# Access Compliance Report Public Rights-of-Way (Curb Ramps)

Intersection ID: 3351	Main Street: FAIRLEA_DR	Cross Street: PROSPERITY_CHURCH_RD	Location: S
ADA ID: E7BFA4F9A09D	Ramp Type: PerpDiag	Initial Pass/Fail: Fail	Overall Compliance: No Severity Score: 33.75

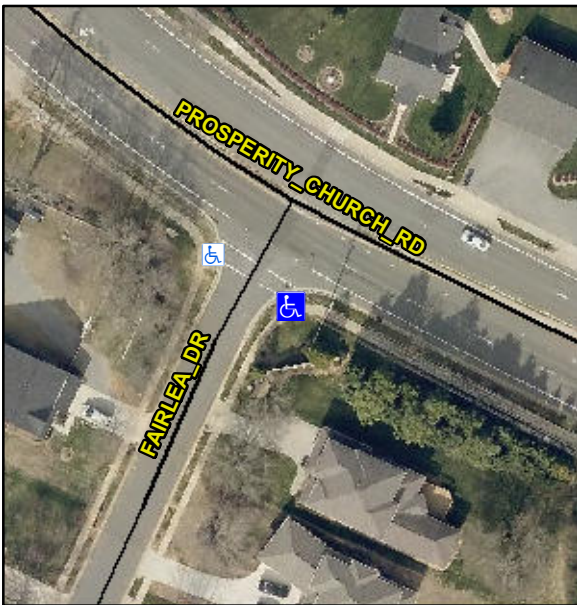
**Not Found, R304.5.1, R304.5.3**

Compliance	Description	Data	Compliance	Description	Data
N/A	Ramp Length (in)	71.5	Yes	Ramp Slope (%)	7.8
No	Ramp Width (in)	36.5	No	Ramp XSlope (%)	7.9
N/A	Flare Type LT	N/A	N/A	Flare Type RT	N/A
N/A	Flare Slope LT (%)	N/A	N/A	Flare Slope RT (%)	N/A
N/A	Flare Traversable LT?	N/A	N/A	Flare Traversable RT?	N/A
N/A	Landing Length (in)	N/A	N/A	DWS Provided?	N/A
N/A	Landing Width (in)	N/A	N/A	DWS Contrast?	N/A
N/A	Landing Slope (%)	N/A	N/A	DWS Length (in)	N/A
N/A	Landing X Slope (%)	N/A	N/A	DWS Full Width?	N/A
N/A	Landing Curb? (Y/N)	N/A	N/A	DWS Offset (in)	N/A
N/A	Shared Landing?	N/A			
N/A	Gutter Ponding?	N/A	N/A	Gutter Slope (%)	N/A
N/A	Gutter Lip Ht (in)	N/A	N/A	Gutter X Slope (%)	N/A
N/A	Painted X Walk1?	No	N/A	Painted X Walk2?	Yes
	X Walk 1 Direction	To NE		X Walk 2 Direction	To NW
N/A	X Walk 1 Width (in)	N/A	N/A	X Walk 2 Width (in)	91.0
	X Walk 1 Slope (%)	0.3		X Walk 2 Slope (%)	0.2
	X Walk 1 X Slope (%)	2.8		X Walk 2 X Slope (%)	4.6

N/A	Ramp inside XWalk1?	N/A	N/A	Ramp inside XWalk2?	Yes
	Road Slope (%)	5.0	N/A	Clear Space?	N/A
	Road X Slope (%)	0.4	N/A	Clear Space to XWalk (in)	N/A
N/A	Any Obstructions?	N/A	N/A	Storm Grate/Utility Hazard?	N/A
	Obstruction Type			Storm Grate/Utility Type	
		N/A			N/A
			Yes	Surface Condition? (G/P)	Good

**Remove & Replace Curb Ramp With Two New Directional Ramps or Equivalent.**
